CPED STAFF REPORT

CPC Agenda Item #11
 August 11, 2014
 BZZ-6675

Property Location: 2004, 2008, 2012, 2014, and 2018 Lyndale Avenue South
Project Name: Theatre Garage and Marquee Apartments
Prepared By: [Mei-Ling Anderson](#), City Planner, (612) 673-5342
Applicant: TGMA Developers, LLC
Project Contact: Elizabeth Liebhard, Master Properties MN
Request: To construct a new, six-story mixed-use building with 82 dwelling units.
Required Applications:

C0.0

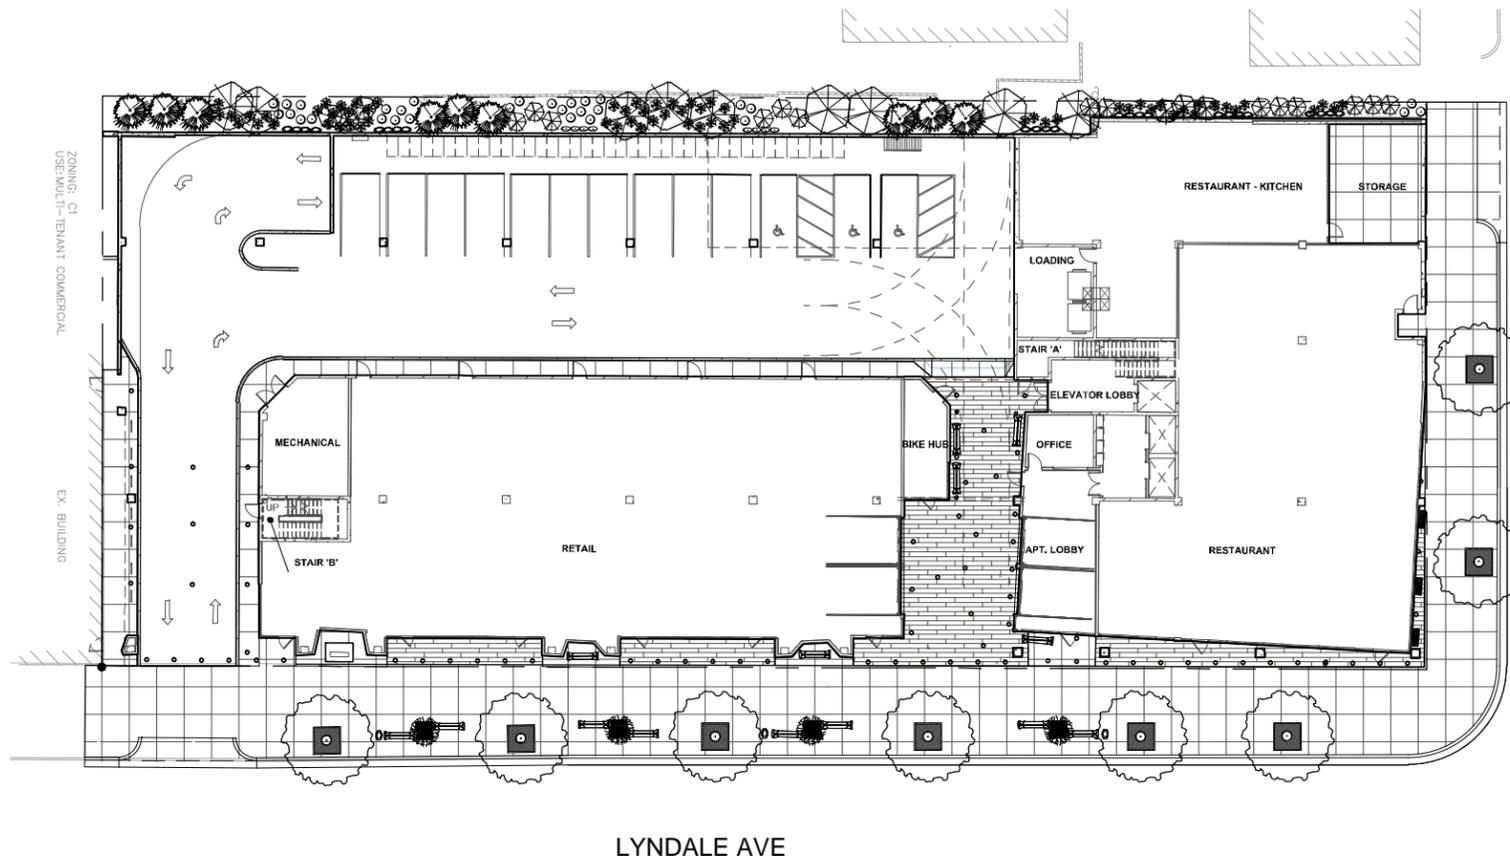
- The sidewalk layout shown on the Site Plan (Sheet C2.0) and the Landscaping Plan (Sheet L1.0) does not adequately detail all of the proposed encroachments in the Public right-of-way. The Applicant shall include the actual design details necessary to fully describe the streetscape and landscaping design. Details and standard plates for decorative paving, planters, benches, tree grates, tree planting shall be included in the plans. Decorative pavements and sidewalk features are generally not recommended within the pedestrian thru-zone of the Public sidewalk. Please contact Paul Miller at (612) 673-3603 for further information
